COUNTY COUNCIL'S RESPONSE TO CONSULTATION ON THE FOLLOWING DEVELOPMENT PROPOSAL

Application No: 18/00825/HYBRID-2

Proposal: Demolition of buildings and structures as listed in Schedule 1; Outline planning permission for up to 1,175 new dwellings (Class C3); 60 close care dwellings (Class C2/C3); 929 m2 of retail (Class A1); 670 m2 comprising a new medical centre (Class D1); 35,175 m2 of new employment buildings, (comprising up to 6,330 m2 Class B1a, 13,635 m2 B1b/c, 9,250 m2 Class B2, and 5,960 m2 B8); 2.4 ha site for a new school (Class D1); 925 m2 of community use buildings (Class D2); and 515 m2 of indoor sports, if provided on-site (Class D2); 30m in height observation tower with zip-wire with ancillary visitor facilities of up to 100 m2 (Class D1/A1/A3); 1,000 m2 energy facility/infrastructure with a stack height of up to 24m (sui generis); 2,520 m2 additional education facilities (buildings and associated external infrastructure) at Buildings 73, 74 and 583 for education use (Class D1); creation of areas of Open Space, Sports Facilities, Public Park and other green infrastructure; Change of Use of the following buildings and areas: Buildings 357 and 370 for office use (Clas

Footway between Pye Homes and Camp Road

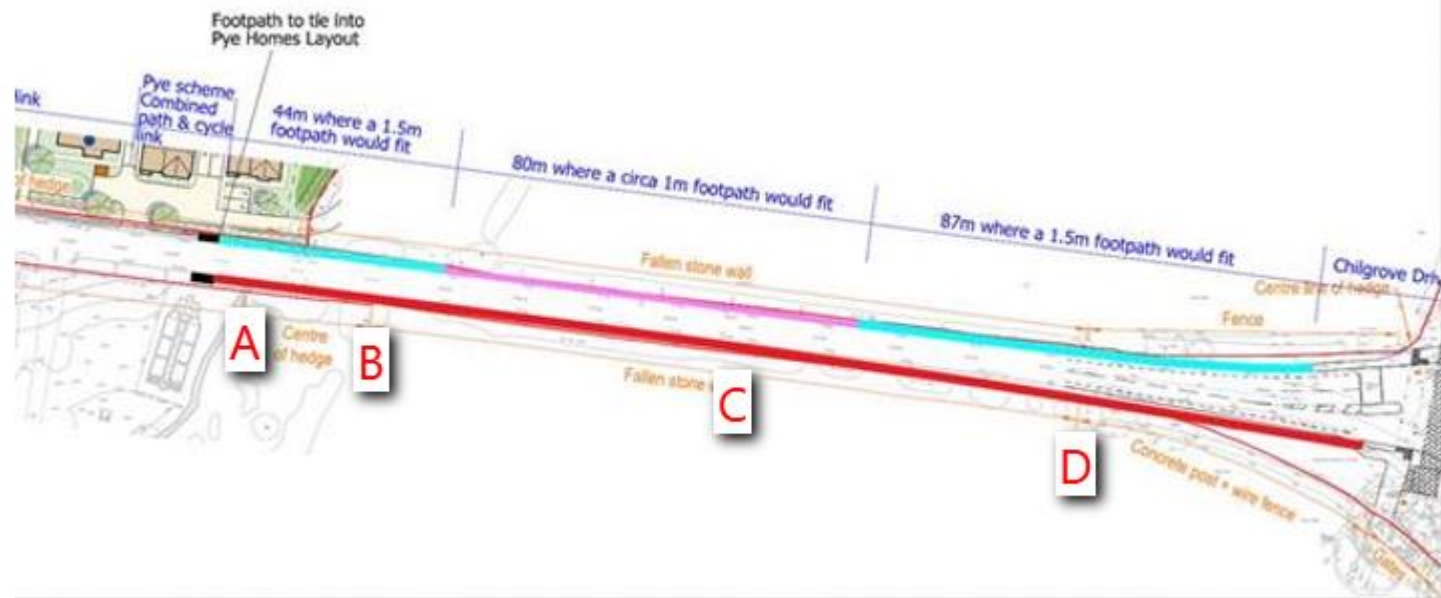
An assessment of the connection between Pye Homes and Chilgrove Drive was undertaken by Woods Hardwick and set out the likely feasible width for a proposed footway a long this section of highway taking into account the existing constraints.

It is noted that the existing carriageway is between 5.7m and 6.0m wide in this location. It is therefore not considered feasible to narrow the carriageway further given the requirement for two-way bus movement along this route. It should also be noted that OCC have requested that this section of highway has the centre line removed and advisory cycle lanes shown on both sides. This will further narrow the useable width of the carriageway. On this basis it is not considered feasible to reduce the width of the carriageway to provide a wider footway.

On the southern side of the carriageway level differences limit the ability to provide a footway or realign the carriageway to enable a tie in within the existing highway boundary.

OCC: Because of the importance to this footway link in the masterplan, linking proposed residential development to employment and public rights of way, the detail is extremely important in coming to a conclusion as to whether the footway is

<p>feasible, and I repeat that OCC would like to see the Woods Hardwick assessment. I note that the smaller site on Camp Road referred to, which was considered in the absence of the masterplan, does not yet have a planning permission. The Schedule referred to has not been formally submitted as part of this planning application and is not finalised. In any event, the developer of that site would be subject to the same physical constraints.</p> <p>With regard to routing through the main site referred to above, Figure 5.1 Rev B shows that the route to the employment areas off Chilgrove Drive from residential areas at the eastern end of Camp Road would be much less direct than via Chilgrove Drive, and so there is a significant risk that pedestrians would walk along the narrow verge in the absence of a footway, and this represents a safety hazard.</p>
<p>Canal Towpath Contribution</p>	
	<p>Following submission of the original TA, OCC requested that a contribution be provided towards improvements of the towpath foot / cycleway link between Allens Bridge and Station Road Bridge on the Oxford Canal. Further discussions have since been held with OCC and it has been agreed that these contributions would be better directed towards the provision of a cycle route between Camp Road and Bicester if this route could be delivered (See Section 5 of meeting minutes at Appendix C). On this basis no contributions towards the canal towpath are proposed.</p> <p>Accepted. See comments in main response under Rights of Way.</p>

- **Shape of school site**

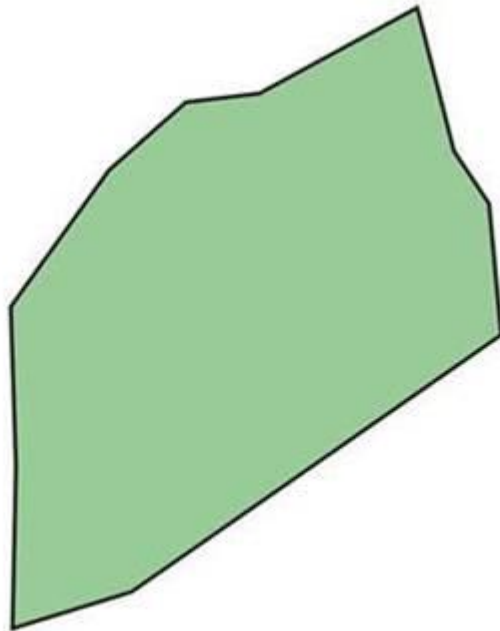
It has not been demonstrated that the proposed shape of the school site is conducive to the creation of an economic layout for the school or to provide the minimum external play areas requirements. The current shape doesn't appear to fit the basic OCC playing field requirements without further compromising the other areas of the site.

A distorted playing fields provision would not be accepted with its potential to compromise the delivery of a team games playing field to meet curriculum requirements.
